PROPOSED COMPREHENSIVE PLAN AMENDMENT ADDENDUM

ITEM: SSPA 2018-1-1MS

Date of Addendum: September 10, 2019

SITE-SPECIFIC PLAN AMENDMENT 2018-I-1MS STAFF REPORT ADDENDUM

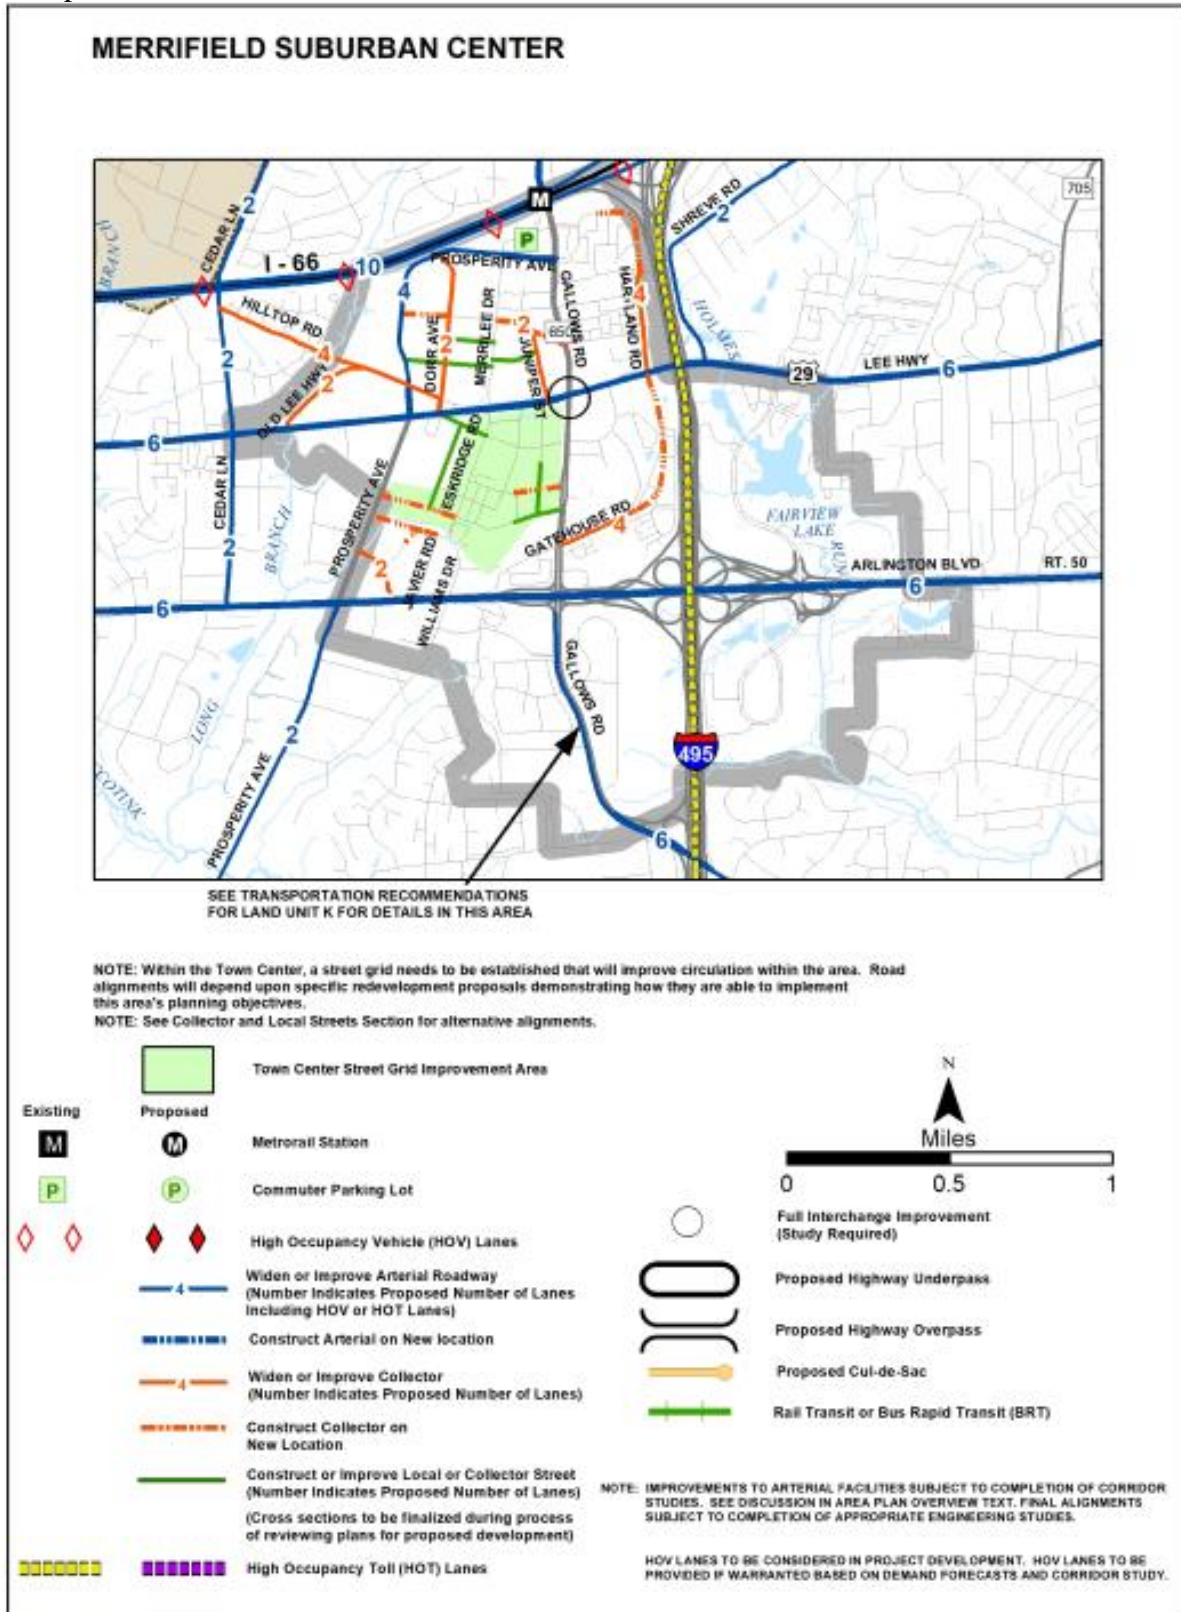
1309 **MODIFY FIGURE:** Fairfax County Comprehensive Plan, 2017 Edition, Area I, Merrifield
 1310 Suburban Center, Area-Wide Guidance, as amended through July 31, 2018, Figure 16,
 1311 Transportation Recommendations, page 43, to add a note that references additional
 1312 transportation recommendations in Land Unit K.

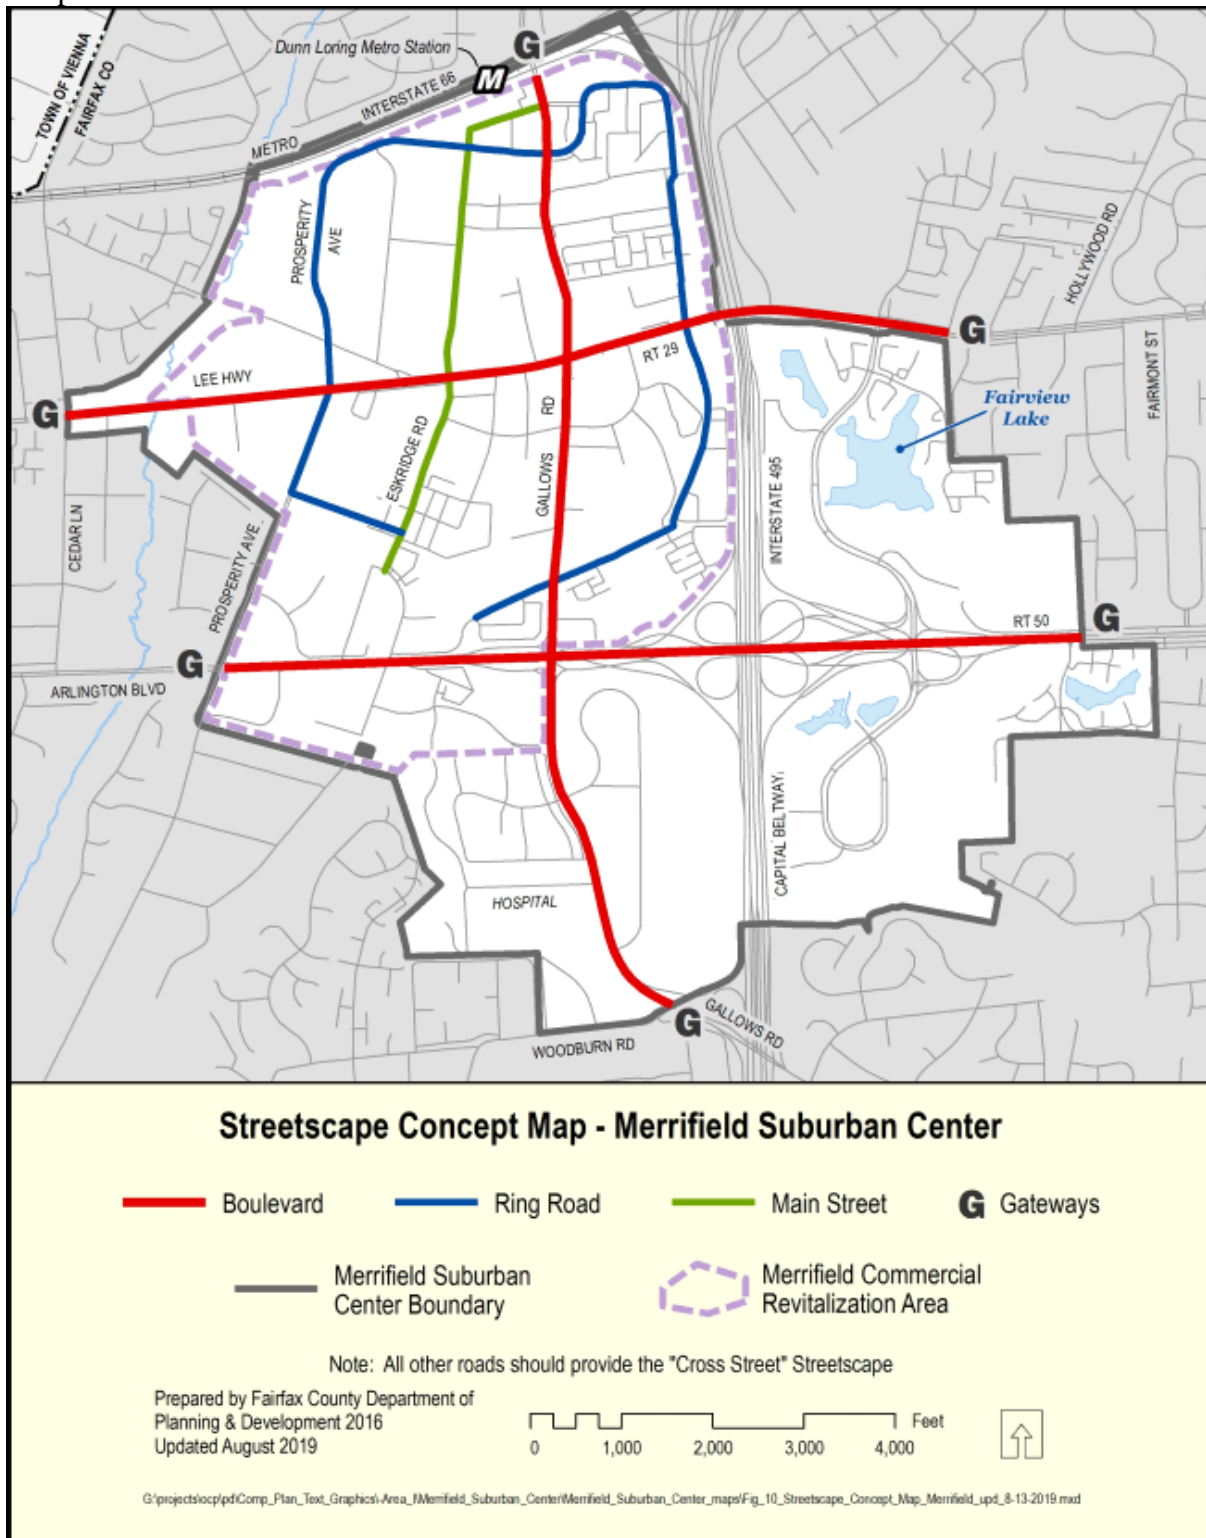
1314 **MODIFY FIGURE:** Fairfax County Comprehensive Plan, 2017 Edition, Area I, Merrifield
 1315 Suburban Center, Area-wide Guidance, as amended through July 31, 2018, Figure 10, page 28 to
 1316 move the word “HOSPITAL” further south to reflect the accurate location of Inova Fairfax
 1317 Hospital.
